September 1, 2015

Re: 2BB-MAE--- Madrid Bulk Sample Type B Water Licence Application - Responses to Comments Received

Figure 3-16: Comparison of Stable Nickel Release Rates and Nickel Content

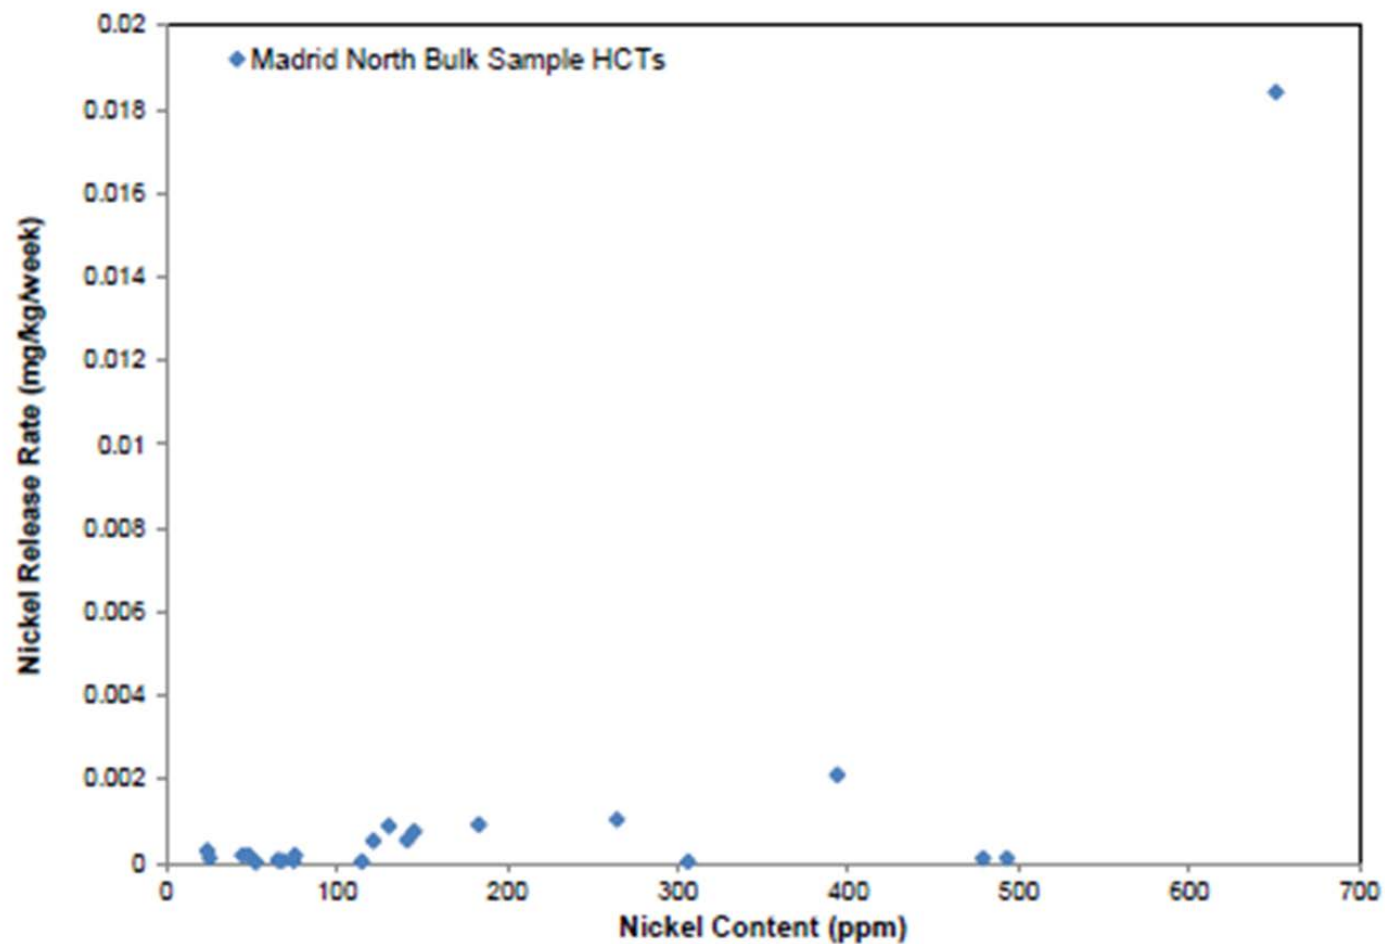
Kinetic Test Results				
E3	Section 2.1.3 of Appendix 08B	The Proponent states that the pH levels for the barrel tests were alkaline, with field and lab values typically between 8 and 8.5. Antimony, arsenic, cobalt and nickel release rates were higher for the sample containing sedimentary units (5+1) and to a lesser degree for deformation zone (13a). The Proponent concludes that the kinetic test results suggest that arsenic and nickel leaching under neutral pH conditions is expected from materials containing the trace mineral gersdorffite. The Proponent further concludes that as there is no practical means of identifying gersdorffite during mining, and that waste rock cannot be segregated and managed according to arsenic and nickel leaching characteristics.	It is not clear to EC why the wt. % concentration of gersdorffite cannot be used to identify the rock units that may potentially leach arsenic and nickel as these metals are related to gersdorffite just as wt. % of sulphide is used to identify rock units which may have acid potential. In addition, the preliminary economic classification in table 2 shows that high concentration of arsenic and nickel are in the “O” classification ((HC 26, HC-28 and HC-24) – Mafic Volcanics and Mafic metavolcanics), and rocks with >100% total sulphur (table 2, HC-20 and HC-21). Also, the samples HC-20 and HC-21) not in the “O” classification does show that the TIC/AP ratios are within the uncertain potentially acid generating (PAG) range. EC asks that the Proponent clarify why these indicators could not be used to attempt to separate rock units.	<p>The gersdorffite content of the kinetic test samples was determined using mineral liberation analysis (MLA). MLA and/or QEMSCAN (a very similar method) are the only commercially available methods that can reliably detect and quantify such low concentrations of a specific mineral phase (in this case down to concentrations of <0.01%). However, these methods require highly specialized and expensive analytical equipment that cannot realistically be included in an on site laboratory. In the current waste rock and ore management plans for Doris North, material with a sulphide content is estimated visually, but the cutoff used to define mineralized rock for segregation purposes is at a threshold of 0.5%, which can be detected visually in hand samples.</p> <p>TMAC would like to clarify that the numbers in column 3 of Table 2 show the %rank of the total sulphur content relative to the Madrid North sample set as an indication of how representative these samples are of the Madrid</p>

ISSUE E3: Kinetic Test Results - Arsenic

ISSUE E3: Kinetic Test Results - Nickel

<p>North deposit area. Some of the values exceed a rank of 100% because they are from other deposits in the Madrid North area. Additionally, due to a report typo, sulphur was omitted from the title of column 5. Column 5 provides the total sulphur content (%) of these samples.</p> <p>As noted, samples with higher sulphur content tend to have higher total arsenic and nickel concentrations and lower TIC/AP ratios. However, solid phase arsenic and nickel concentrations were only weakly correlated with arsenic or nickel leaching (see Figures 3-13 and 3-16 from SRK 2015 – appended below), suggesting that even if the rock was segregated according to arsenic and/or nickel content, there would be no guarantee that arsenic concentrations in the seepage from a segregated stockpile would be at an appropriate level for discharge. Additionally, without additional on-site analytical equipment, quantification of the arsenic and nickel content is not possible at this site.</p> <p>To address both the practical concerns associated with segregation and the uncertain level of benefits, TMAC has taken a conservative approach in developing water management and closure plans for the waste rock at Madrid that address the potential for elevated arsenic and nickel concentrations in the contact water from un-segregated waste rock, and believes that these plans are the most appropriate means of addressing the potential water quality issues.</p>

Figure 1. Wildlife Study Area

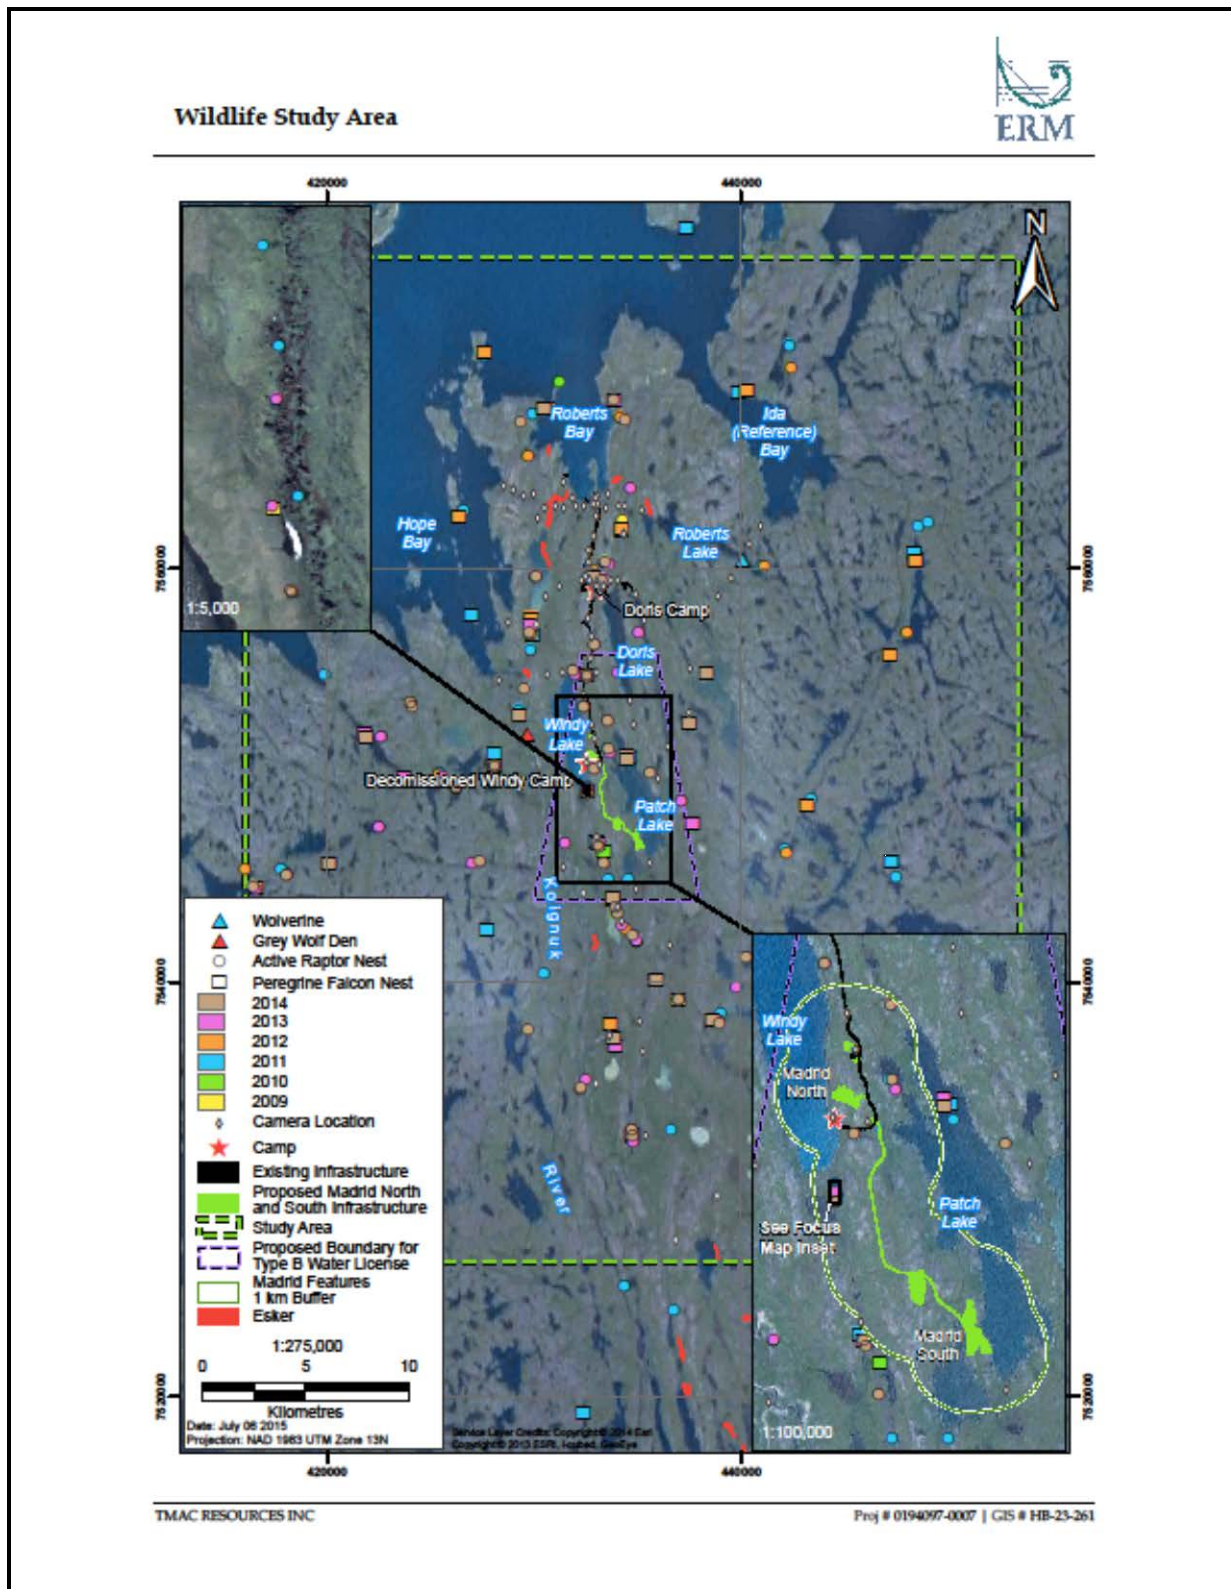
Issue # 11 General Lack of Information on Baseline Results within Madrid Advanced Exploration Area				
K11	Baseline	<p>Appendix 5, Environmental Baseline Part 6, Sections 3.2.1.1 to 3.2.3.2, p.3-7 to 3-10: The sections of Appendix 5 that summarize the wildlife baseline information collected for the Hope Bay belt project do not contextualize the findings spatially, meaning impacts cannot be determined for the Type B Water Licence Application boundary. As this is baseline information is meant to support a water licence application for the application zone shown in Figure 1.1-2 of Appendix 5 (part 1), critical wildlife use and habitat information should be summarized for within that boundary, particularly where critical wildlife habitat features could be destroyed through project development.</p> <p>For example, sections 2.2.2.2 and 2.2.2.3 include vague information on dens, in statements such as: "Carnivore den surveys located three wolf dens in the Hope Bay Belt area," yet no information is provided [sic] as to whether these dens overlap with the application boundary for the Madrid advanced exploration project.</p> <p>Similar issues occur with regard to other wildlife VECs as well; information on the types and numbers of surveys conducted is provided, but no spatially specific information is included about use of the area within the proposed Type B Water Licence application boundary.</p>	<p>TMAC updates this information such that it explicitly summarizes the key habitat use and observations for each wildlife VEC within the proposed application boundary.</p>	<p>See response appended below</p>

Issue K11 General Lack of Information on Baseline Results within Madrid Advanced Exploration Area

Six terrestrial fauna or bird VECs were identified during the Doris North Project EIS consultation process (caribou, wolverine, grizzly bear, upland breeding birds, waterfowl and raptors). Baseline and monitoring studies for these wildlife species were conducted between 2009 and 2014 within a wildlife study area (Figure 1) encompassing the geographical area of the Madrid Advanced Exploration Program, and therefore they are considered appropriate in identifying the effects for this application for the Madrid Advance Exploration Program.

Mammal observations have primarily come from the remote camera program while bird observations are from point counts and prism plots for upland birds and aerial surveys for raptors and waterbirds as well as incidental observations for all species (Figure 1).

Plate1: Crossing #1 Looking Downstream

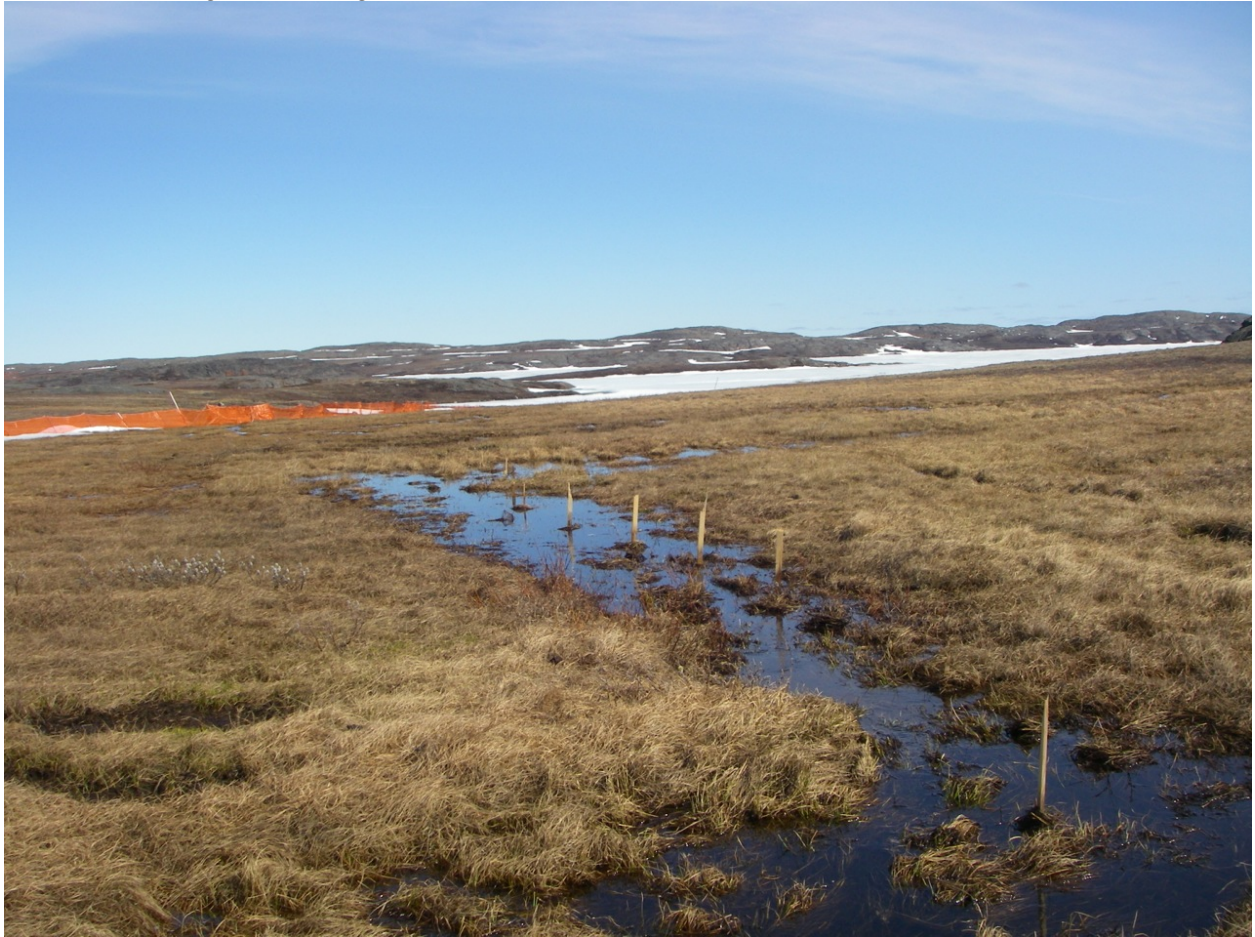
Issue # 23 Sampling information for Crossing #1				
K23	Appendix 5	App. 5, Part 7, P. 4-3: Crossing #1 was determined to not support fish during 2010 fisheries assessments. The detailed sampling information was not located.	Please indicate the details (e.g. sampling effort and timing) of the sampling surveys conducted to determine the non-fish bearing status at Crossing #1. Fish habitat information and photo documentation of the area would also be useful.	<p>Fish community sampling was conducted at Crossing #1 on August 24, 2010 and fish habitat was assessed on September 5-10, 2010 and again June 29, 2011. Fish Community sampling consisted of electrofishing the length of wetted stream (893 s) and minnow trapping the upstream ponds (4 traps set overnight). No fish were captured and this information is summarized on page 4-3 of Appendix 5. In addition, the 2010 baseline report (Rescan 2011) indicates that Crossing #1 (labelled stream N22) has marginal to no fisheries value when considering spawning, rearing and overwintering capacity (Table 3.1-4a in 2010 report). All ponds were less than 1.2 m depth and likely to freeze overwinter. The stream was found to be quite acidic (pH 4.89) and may potentially inhibit fish use. A Sensitive Habitat Index Mapping (SHIM) survey was completed between September 5-10, 2010, which indicated the stream is more characteristic of a wetland with ephemeral connection to Patch Lake (downstream) and the upstream ponds (Figure 3.1-19c in 2010).</p> <p>A photograph of the area is provided below (Plate 1).</p>

Issue # K23: Sampling information for Crossing #1

Figure 1.1-2 (Revised)

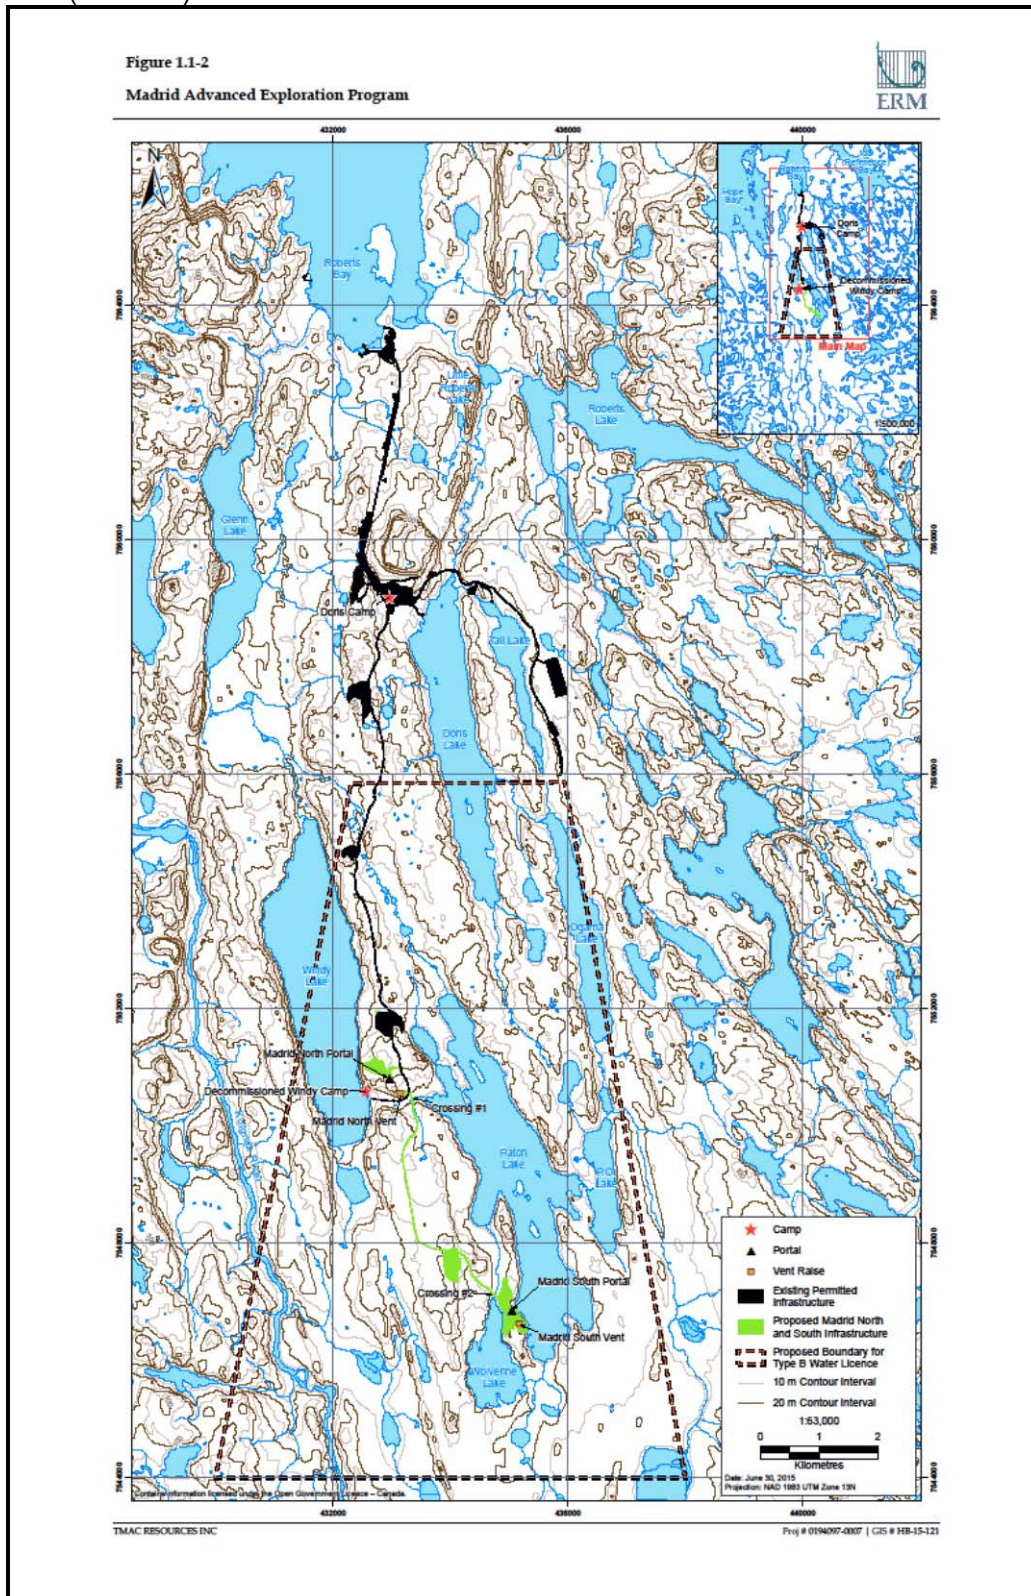
Issue # 24 Location of Wolverine Lake Outflows				
K24	Appendix 5	App. 5, Part 7, P. 4-2: It is noted that Wolverine Lake has two outflows that connect this lake to Patch Lake; one flows to the north (Crossing #2) and one to the east. The eastern outflow was not located on the map (Figure 3.3-1, P.3-14), and it appears that it may be in or near the proposed south portal footprint.	Please indicate the location of the eastern outflow on a figure, and assess if and how it will be impacted by the project.	The eastern outflow of Wolverine Lake that connects this lake to Patch Lake is now presented in revised Figure 1.1-2 appended below. (For consistency, this stream has also been added to Figures 2.5-2, 2.5-3, 2.5-4, and 2.5-7, 3.3-1). The eastern outflow of Wolverine Lake is not within the footprint of the Madrid South development and therefore will not be impacted.
Issue # 25 Freshwater requirements

Issue # K24 Location of Wolverine Lake Outflows
